Access Compliance Report Public Rights-of-Way (Curb Ramps)

Intersection ID: 28226Main Street: CADBURY_CTCross Street: DARBY_CHASE_DRLocation:NEADA ID: 8969B134880FRamp Type: PerpInitial Pass/Fail: FailOverall Compliance: NoSeverity Score:10

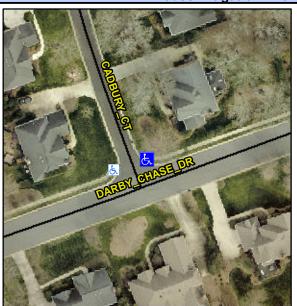
Possible Solutions:	9	
Remove & Replace Entire Ramp.		
	N	
	N	
	N	
	N	
	N	
Surveyor Notes:	N	
N/A	N	
	N	
	N	
	N	
PROW/ADA:	N	
Not Found, R304.5.1, R304.5.3	N	
	N	
	N	
	N

Comp	liance Description	Data	Comp	liance	Description	Data
N/A	Ramp Length (in)	48.0	Yes	Ramp Slope (%)		7.1
No	Ramp Width (in)	43.0	No	Ramp	2.1	
N/A	Flare Type LT	N/A	N/A	Flare	N/A	
N/A	Flare Slope LT (%)	N/A	N/A	Flare	Slope RT (%)	N/A
N/A	Flare Traversable LT?	N/A	N/A	Flare	Traversable RT?	N/A
N/A	Landing Length (in)	N/A	N/A	DWS	Provided?	N/A
N/A	Landing Width (in)	N/A	N/A	DWS	Contrast?	N/A
N/A	Landing Slope (%)	N/A	N/A	DWS	Length (in)	N/A
N/A	Landing X Slope (%)	N/A	N/A	DWS	Full Width?	N/A
N/A	Landing Curb? (Y/N)	N/A	N/A	DWS	Offset (in)	N/A
N/A	Shared Landing?	N/A				
N/A	Gutter Ponding?	N/A	N/A	Gutte	r Slope (%)	N/A
N/A	Gutter Lip Ht (in)	0.5	N/A	Gutte	r X Slope (%)	N/A
N/A	Painted X Walk1?	No	N/A	Paint	ed X Walk2?	N/A
	X Walk 1 Direction	To SW		X Wa	lk 2 Direction	N/A
N/A	X Walk 1 Width (in)	N/A	N/A	X Wa	lk 2 Width (in)	N/A
	X Walk 1 Slope (%)	0.3		X Wa	lk 2 Slope (%)	N/A
	X Walk 1 X Slope (%)	2.3		X Wa	lk 2 X Slope (%)	N/A
